<b>Office Action Summary</b>	<b>Application No.</b> 10/523,752	<b>Applicant(s)</b> KIENINGER ET AL.	
	<b>Examiner</b> ROCCO ITALIANO	<b>Art Unit</b> 3746

## **DETAILED ACTION**

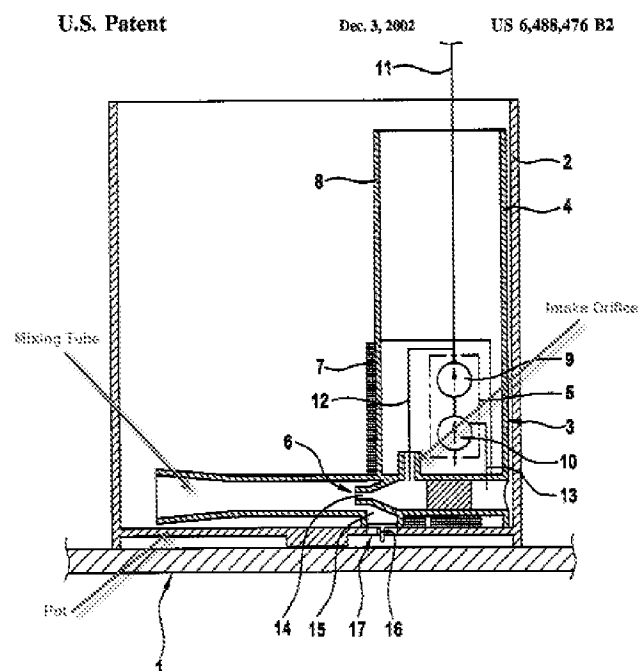
In regards to claim 1, Eck discloses a suction jet pump (6) comprising of a propulsion jet nozzle (14), which can be interpreted from Fig. 1 as structurally consisting of a round nozzle orifice as claimed. Eck discloses further a mixing tube; an intake orifice and a suction line (12) arranged thereon, wherein at least part of the mixing tube is arranged in a pot, assigned to a baffle (2) (see Fig. 1 labeled by examiner for clarity).

With respect to claim 2, the illustration of Fig.1 according to Eck discloses the outlet orifice of the mixing tube is arranged inside the pot (see Fig. 1 labeled by examiner for clarity).

In regards to claims 6 and 10, it can be seen in Fig. 1 according to Eck that the pot is connected to the suction jet pump (6). Furthermore, Fig. 1 illustrated that the pot is formed on a baffle (2).

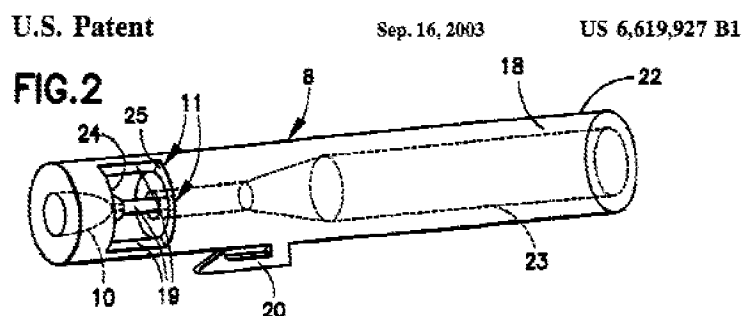
In regards to claims 3 and 4, as best understood, Eck discloses the claimed invention; however no explicit mention is made with regards to the vertical/horizontal arrangement of the mixing tube. However, it would have been obvious to one having ordinary skill in the art at the time of the invention was made to position a suction jet pump wherein the mixing tube is arranged at an angle deviating from a designated horizontal axis or in a vertically arranged position, since it has been held that rearranging parts of an invention involves only routine skill in the art. In re Japiske, 86 USPQ 70.

With respect to claim 5, Eck does not provide any specific statement whereby the angular relationship of the mixing tube is defined. It would have been obvious to one of ordinary skill in the art at the time of the invention was made to determine an appropriate an angle at which to position the mixing tube, since it has been held that where the general conditions of a claim are disclosed in the prior art, discovering the optimum or workable ranges involves only routine skill in the art. In re Aller, 105 USPQ 233.

In regards to claim 8, Eck discloses the claimed invention; however no specific disclosure is made with regards to the pot being integrally formed on the suction jet pump. It would be obvious to one having ordinary skill in the art at the time of the invention was made to integrally form the element, since it has been held that forming in one piece an article which has formerly been formed in two pieces and put together involves only routine skill in the art. *Howard v. Detroit Works*, 150 U.S. 164 (1993).
